DESIGN REVIEW
RECOMMENDATION PROPOSAL

3400 Wallingford Ave N - 3014232
3326 Wallingford Ave N - 3014233

Application Date:
August 30, 2013

1. Street Section - North Bldg - Wallingford Ave N

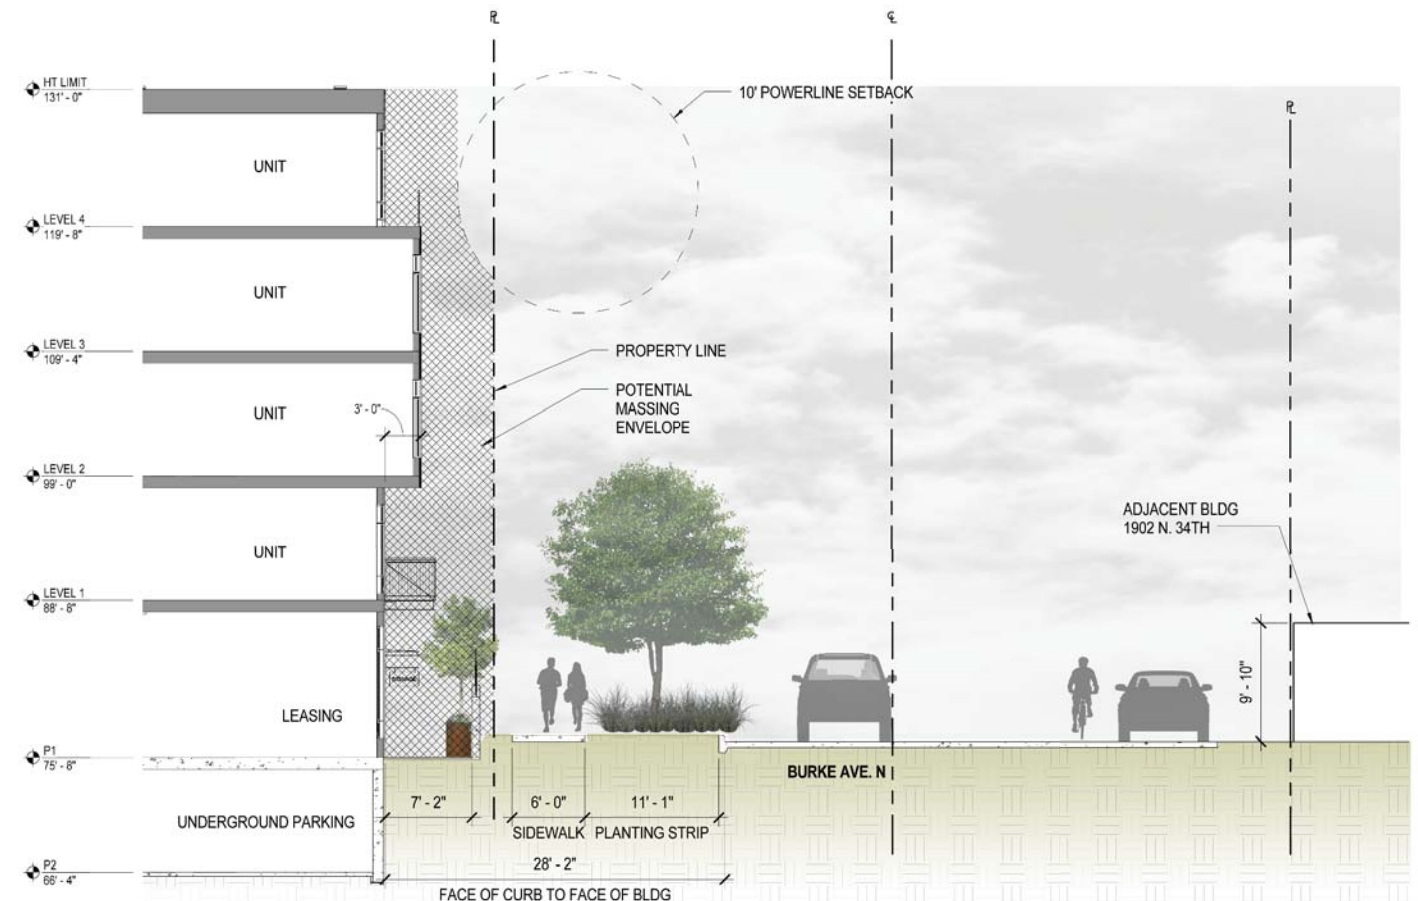
EDG COMMENT:
The project design should honor the Wallingford specific guidance above by setting the upper levels back from the two avenues (to ensure skyline views and to minimize shadows on public sidewalks) and creating outdoor spaces that take advantages of sun exposure.

EDG COMMENT:
Both options # 1 and 3 illustrate an upper level setback on N. 34th St. for the south site. This continuation of the scale of the Varsity restaurant is encouraged.

EDG COMMENT:
Use the Wallingford guidelines above to create gardens and patios fronting the two avenues. A generous area (approximately 15' wide) on Wallingford Ave extending from the curb would allow plantings and patios on both sides of the sidewalk. With the more intimate scale along Burke Ave, the width could potentially be narrower.

EDG COMMENT:
The notion of the upper floors extending over the lower floors at N. 34th and Wallingford Ave and on Burke Ave., as depicted in Option #3, does not meet the Wallingford guidelines.

EDG COMMENT:
Five floors face Burke with much of the upper levels projecting toward the street. Both the structures' lengths and the projecting upper levels represent architectural ideas or patterns counter to the Wallingford specific guidelines .

RESPONSE:
The proposed buildings have upper level setbacks on all streets in excess of those required by code. Additional ground level setbacks provide ground level open space, and pedestrian weather protection both of which were requested in A-2 and A-4 comments below

RESPONSE:
The referenced upper level setback has been maintained. Further, an additional setback is provided on each side of 34th street level, allowing for wider sidewalks and landscaping and an improved pedestrian experience.

RESPONSE:
Building setbacks from both avenues (curb to building face) substantially exceed 15' in all cases.

RESPONSE:
The building has been revised along Burke and Wallingford to provide additional upper level setbacks as described in A-1 and A-5 above. The middle floors extend over the lower floors along 34th, Wallingford and Burke to provide additional weather protection, wider sidewalks for enhanced pedestrian experience and additional space for terraces and galleries in front of live work units as requested in A-4 above.

RESPONSE:
While correct that upper levels project over mid-levels, significant upper level setbacks are provided, achieving the goals of the Wallingford specific guidelines. Lower levels are setback for increased open space, landscaping, and weather protection as described in A-1 and A-10 above .
Similar to the Biscayne, the building along Wallingford and Burke is provided with upper level setbacks as revised in the current plans. Additional setbacks are provided at mid levels and lower levels significantly in excess of code requirements to provide additional openspace and public view opportunities along Wallingford and 34th Street, which are public view corridors. These setbacks significantly increase the open space and view opportunities from the existing conditions which are immediately adjacent to the property lines.

1. Street Section - North and South Bldgs - N 34th Street

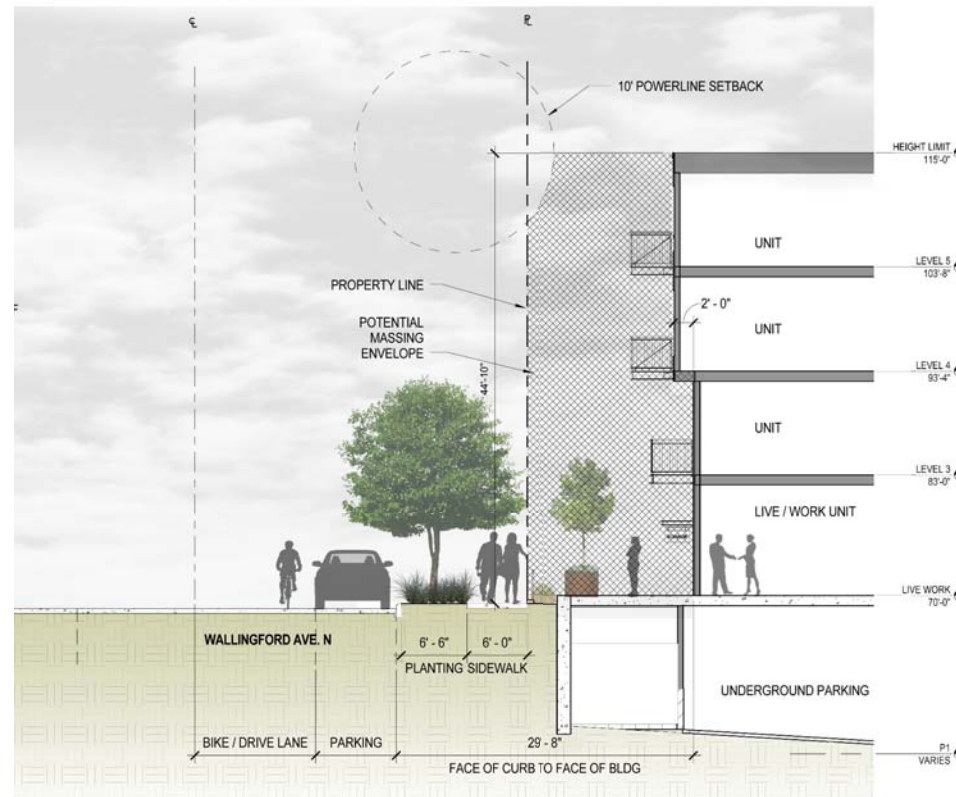
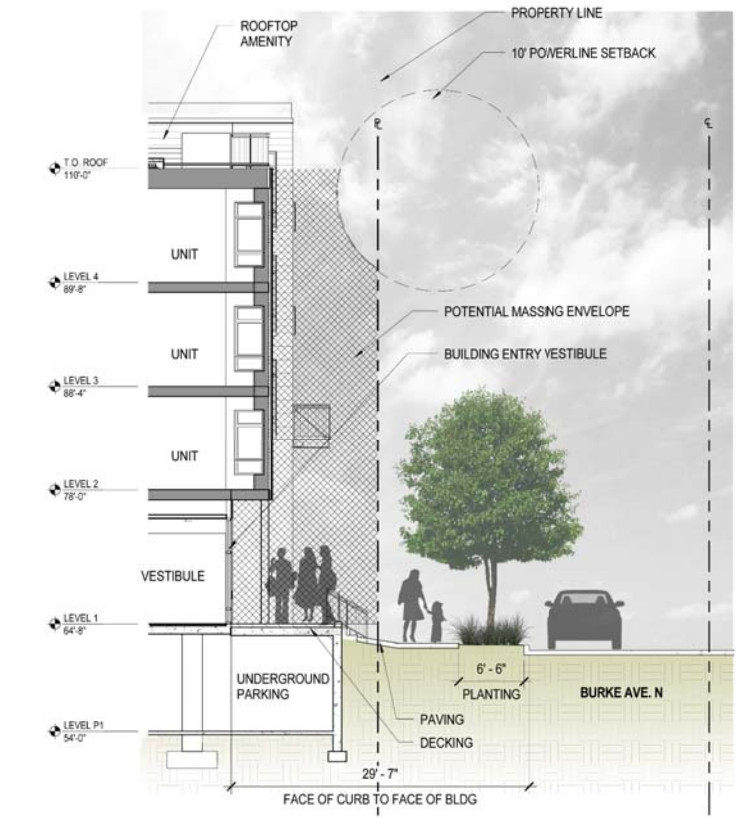
EDG COMMENT:
The project design should honor the Wallingford specific guidance above by setting the upper levels back from the two avenues (to ensure skyline views and to minimize shadows on public sidewalks) and creating outdoor spaces that take advantages of sun exposure.

EDG COMMENT:
Both options # 1 and 3 illustrate an upper level setback on N. 34th St. for the south site. This continuation of the scale of the Varsity restaurant is encouraged.

EDG COMMENT:
Use the Wallingford guidelines above to create gardens and patios fronting the two avenues. A generous area (approximately 15' wide) on Wallingford Ave extending from the curb would allow plantings and patios on both sides of the sidewalk. With the more intimate scale along Burke Ave, the width could potentially be narrower.

EDG COMMENT:
The notion of the upper floors extending over the lower floors at N. 34th and Wallingford Ave and on Burke Ave., as depicted in Option #3, does not meet the Wallingford guidelines.

EDG COMMENT:
Five floors face Burke with much of the upper levels projecting toward the street. Both the structures' lengths and the projecting upper levels represent architectural ideas or patterns counter to the Wallingford specific guidelines .

RESPONSE:
The proposed buildings have upper level setbacks on all streets in excess of those required by code. Additional ground level setbacks provide ground level open space, and pedestrian weather protection both of which were requested in A-2 and A-4 comments below

RESPONSE:
The referenced upper level setback has been maintained. Further, an additional setback is provided on each side of 34th street level, allowing for wider sidewalks and landscaping and an improved pedestrian experience.

RESPONSE:
Building setbacks from both avenues (curb to building face) substantially exceed 15' in all cases.

RESPONSE:
The building has been revised along Burke and Wallingford to provide additional upper level setbacks as described in A-1 and A-5 above. The middle floors extend over the lower floors along 34th, Wallingford and Burke to provide additional weather protection, wider sidewalks for enhanced pedestrian experience and additional space for terraces and galleries in front of live work units as requested in A-4 above.

RESPONSE:
While correct that upper levels project over mid-levels, significant upper level setbacks are provided, achieving the goals of the Wallingford specific guidelines. Lower levels are setback for increased open space, landscaping, and weather protection as described in A-1 and A-10 above .
Similar to the Biscayne, the building along Wallingford and Burke is provided with upper level setbacks as revised in the current plans. Additional setbacks are provided at mid levels and lower levels significantly in excess of code requirements to provide additional openspace and public view opportunities along Wallingford and 34th Street, which are public view corridors. These setbacks significantly increase the open space and view opportunities from the existing conditions which are immediately adjacent to the property lines.

Perspective - South Bldg Live/Work Entries

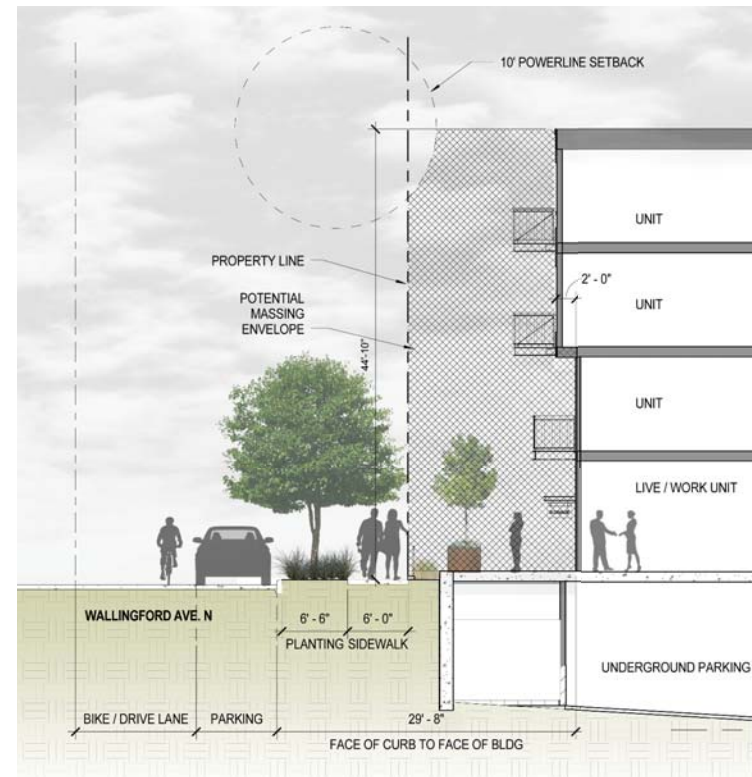
These commercial units ought to meet the grade at the rights of way and provide a commercial appearance at the street frontage with extensive glazing, signage and overhead weather protection. Preferably these units on N. 34th St. should resemble two-story commercial spaces. The design should accommodate a large work area that visually extends from the storefront to the back of the unit.

The location of live work units are delineated on the DRB submittal. Signage, weather protection and large areas of glazing have been provided at the street to create a commercial appearance. Live work units are at least 30 feet deep and 13' tall to allow for a variety of uses. Live work units provide direct and accessible pedestrian access from Burke and Wallingford. The live/work units have also been designed for future flexibility by the incorporation of beams within party walls to allow units to be combined into larger retail spaces should the market demand arise.

Pubic Plaza at 34th and N Wallingford

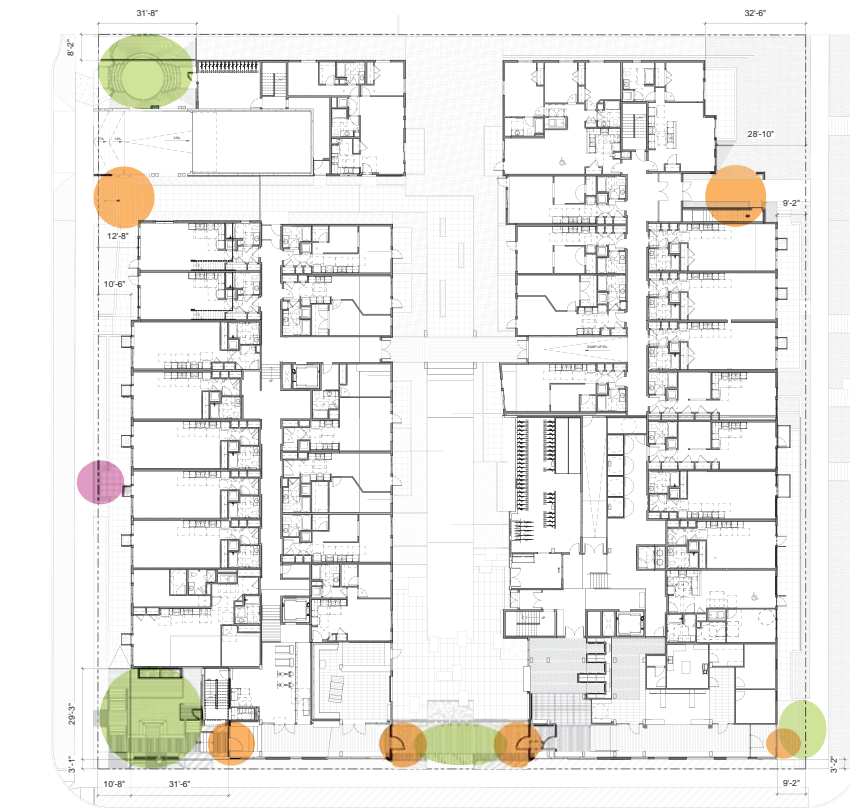
Sizeable plazas, public in nature, should define the primary residential entrances. Staff encourages a significant entrance at the corner of Wallingford Ave and N. 34th St. and another plaza for the south site at the corner of Burke Ave. and N. 34th St.

Open spaces at each of the four primary residential entries (a significant publicly accessible open space at 34th& Wallingford, midblock courtyard at 34th, 34th & Burke plaza, and midblock plaza at Burke) define the entrances and provide publicly accessible space and amenities, such as raised planters, seat walls and benches, greenspace and shade trees, art or water features as applicable, bike racks, etc., achieving the goals of this design guideline.

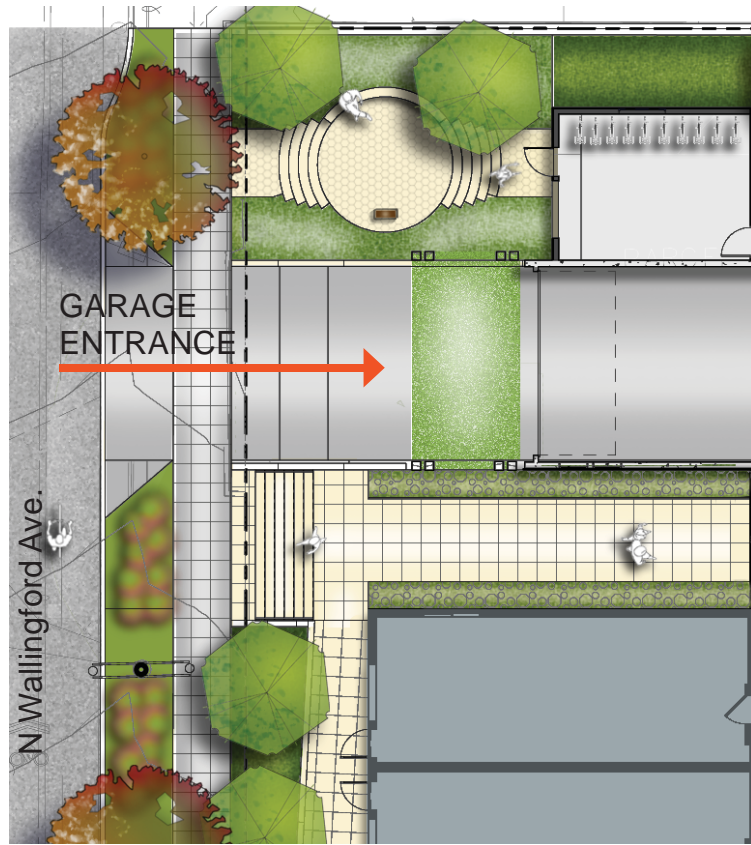
EDG COMMENTS:
The skybridges crossing the open spaces works as a detriment to the plazas and mews by casting shadows and unnecessarily enlarging the scale of the plazas and the complex. Eliminate these to create more intimate and inviting spaces.

RESPONSE:
The skybridge on the north site has been revised to delete the top two stories to reduce the extent of shadow it would cast and to reduce its scale and mass, significantly reducing its prominence in the courtyard.
Both skybridges have been revised to include additional glazing to improve transparency and openness, further reducing mass and scale.
The now light, airy, and open skybridges provide the benefit of breaking up the plazas into defined areas of use. The skybridges also serve to connect buildings together to minimize the need for additional stairs, which would necessitate additional rooftop penthouses, and to improve the sense of community within the buildings.

North Garage Entrance Plan

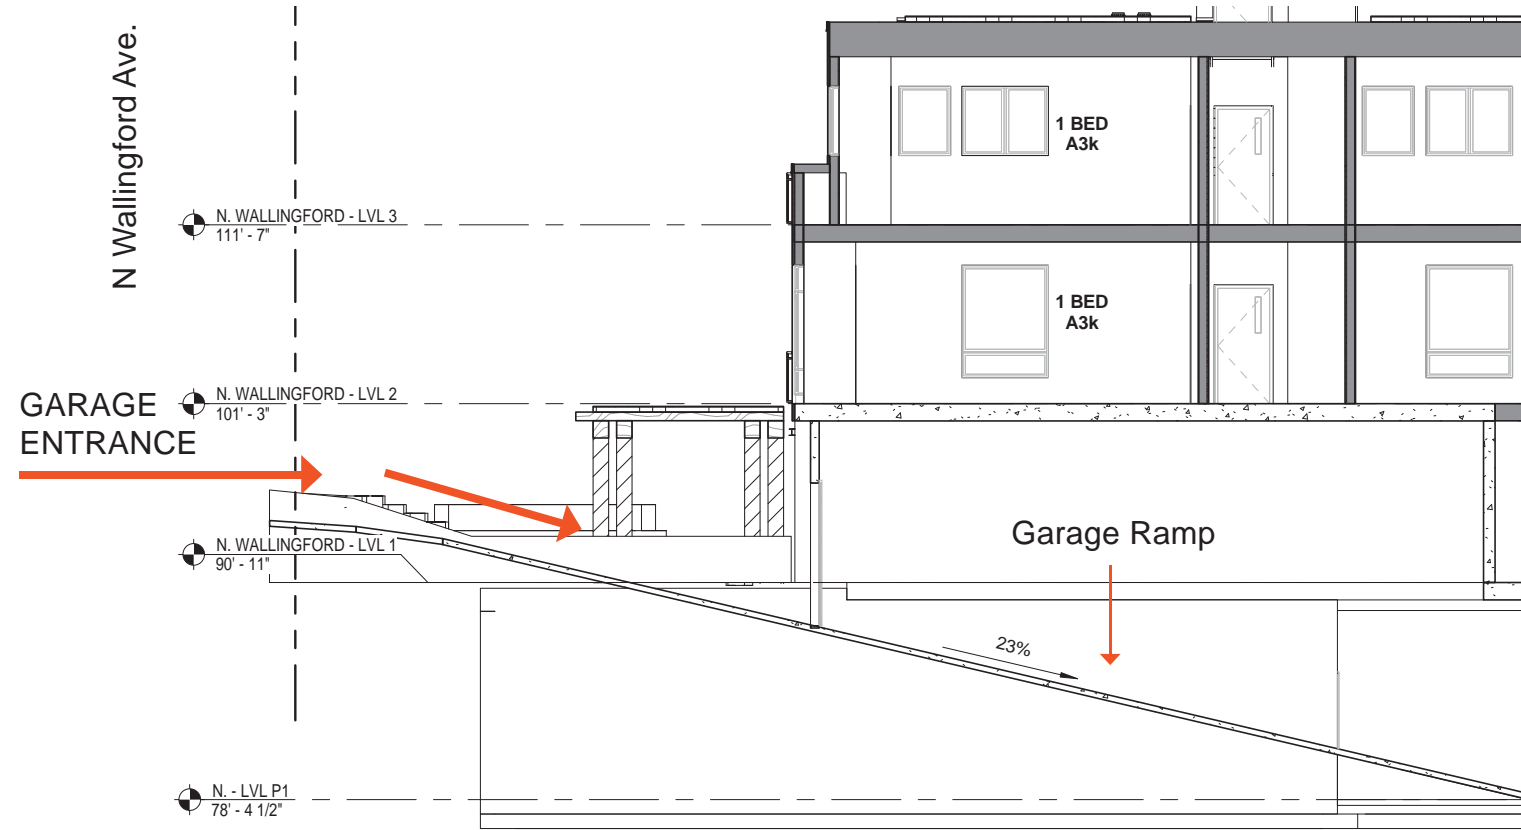
EDG COMMENTS:
Locating garage access for the north site on Burke Ave is problematic for many of the reasons stated in the public comment section. Further exploration of alternative locations needs to occur as well as a study of techniques for directing traffic away from the adjacent lowrise and single family zones.

RESPONSE:
The parking access for the north block has been relocated to Wallingford Avenue, eliminating this issue .

North Garage Entrance Section

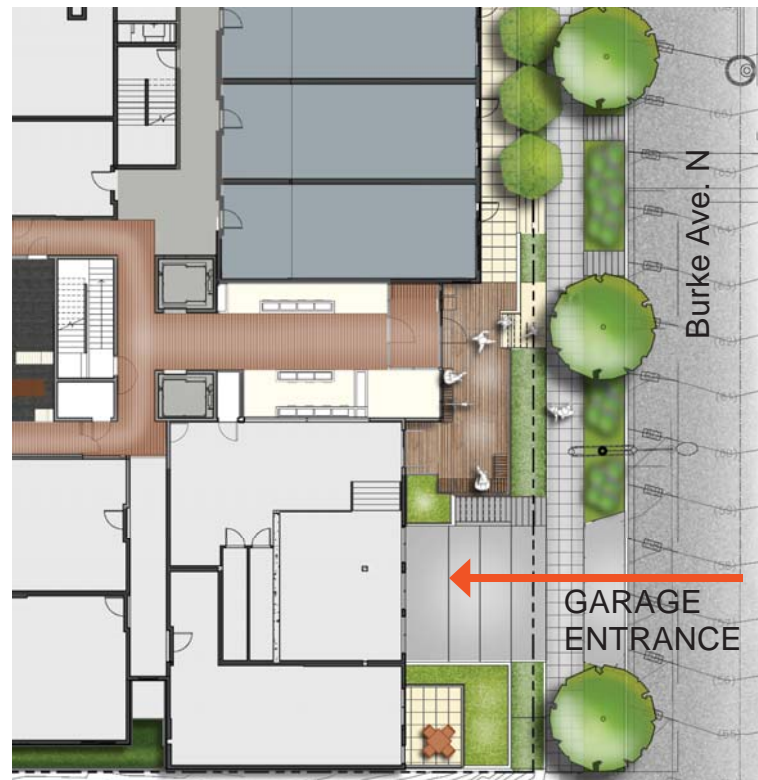
EDG COMMENTS:
The size of garage doors should be minimized as much as possible.

RESPONSE:
Garage doors will be recessed and lowered below grade to minimize visual impacts.

Elevation - S Bldg Mid Block - N 34th St

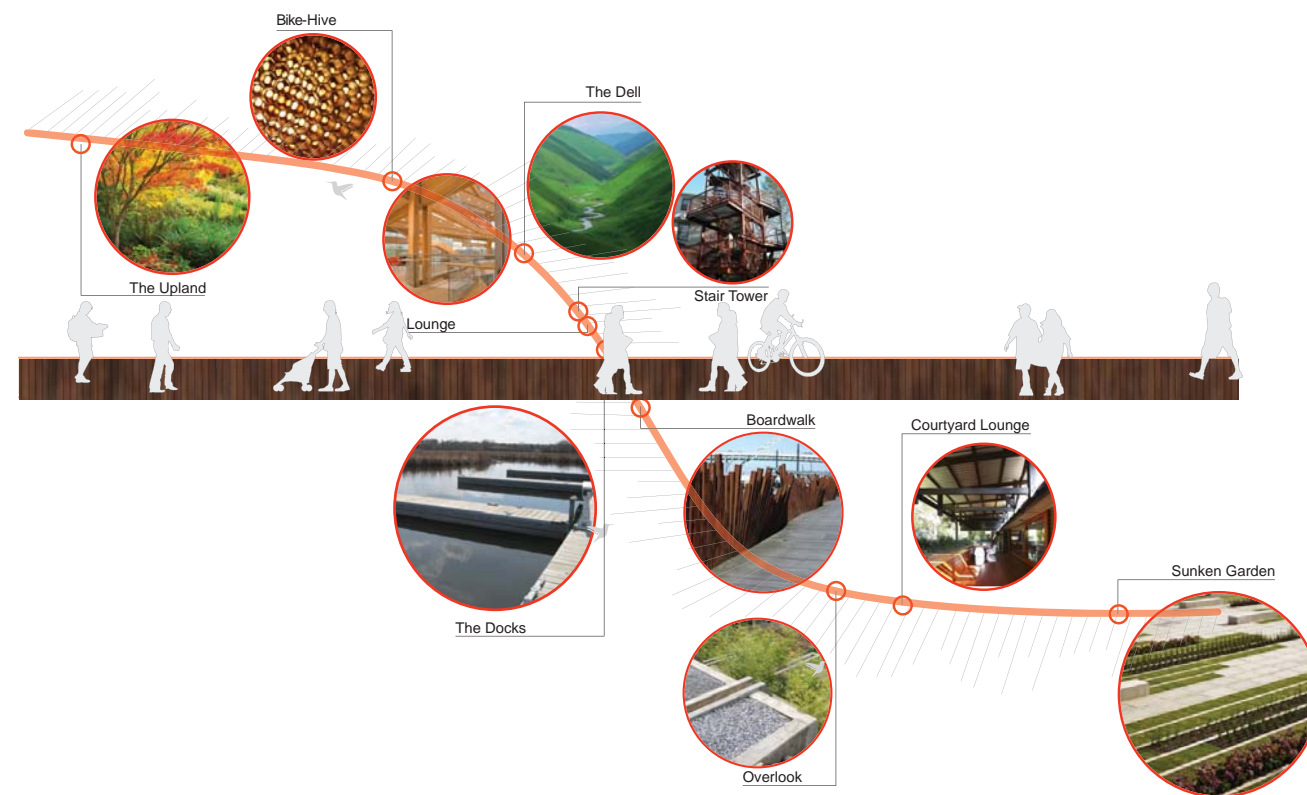
The neighborhood specific guidelines encourage a traditional approach to design. The proposal ought to honor the principles outlined but, as stated above, the imagery does not need to have a historicist character.
